DSA CODE AMENDMENT DEVELOPMENT

Applicable Code Section(s): CBC, Chapter 2 Definitions
 Topic: Multi-bedroom Housing Unit

**FIGURE 11B-809.8.3.1 (3)
PLATFORM AT SECONDARY EXTERIOR DOOR**

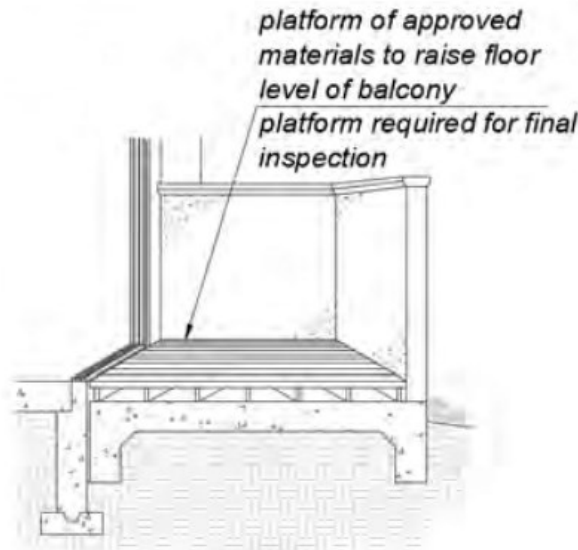
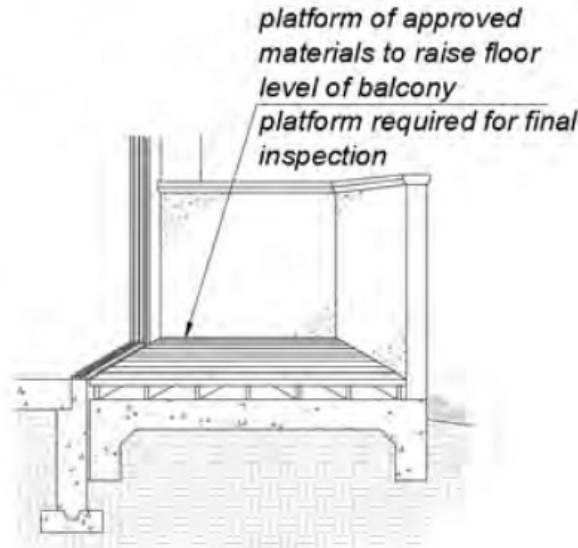
To further clarify the requirements, the existing exceptions in Section 11B-809.8 are proposed to move to the more appropriate location in Section 11B-809.8.3.1.

ramp complying with Section 11B-405 or by means of a platform constructed to the level of the floor as illustrated in Figure 11B-809.8.3.1(3).

FIGURE 11B.809.10.6.3
TRANSFER TYPE SHOWER CLEAR FLOOR SPACE

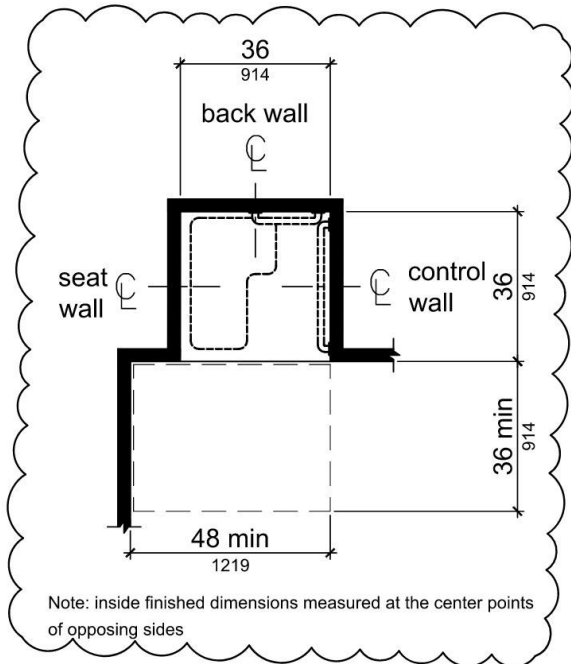
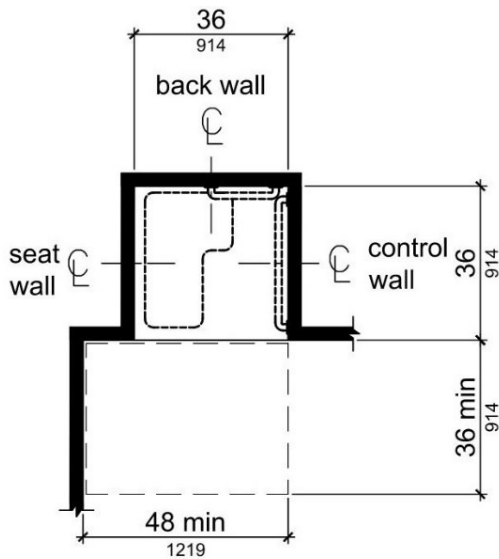
2022 Intervening Rulemaking Cycle, DSA attempted to clarify in Section 11B-809.10.6.1 the reference to Section 11B-608.1, which specifies the size for transfer showers. In addition to the size, the reference provided for a 36" x 48" clear floor space at the shower fixture, and a subsequent reference in Section 11B-809.10.6.3 which specifies a 30" x 48" floor space, provided for conflicting requirements. While the 30" minimum clear floor space width is the minimum permitted by the Fair Housing Act, individuals with disabilities acknowledged the minimum clear floor space requirements were insufficient. The Building Standards Commission did not approve the proposal and requested that DSA provide further study. DSA advances this proposal to increase to 36" wide the clear floor space at all showers in residential dwelling units with adaptable features. A referenced figure is necessary to illustrate the position of the clear floor space relative to the control wall of the shower and ensure the ability to enforce the elements clarified in the figure. (See companion proposal for Section 11B-809.10.6.1.)

11B-809.10.6.3 Clearance. A clearance of 36 inches (914 mm) wide minimum by 48 inches (1219 mm) long minimum measured from the control wall shall be provided outside the shower as illustrated in Figure 11B-809.10.6.3.
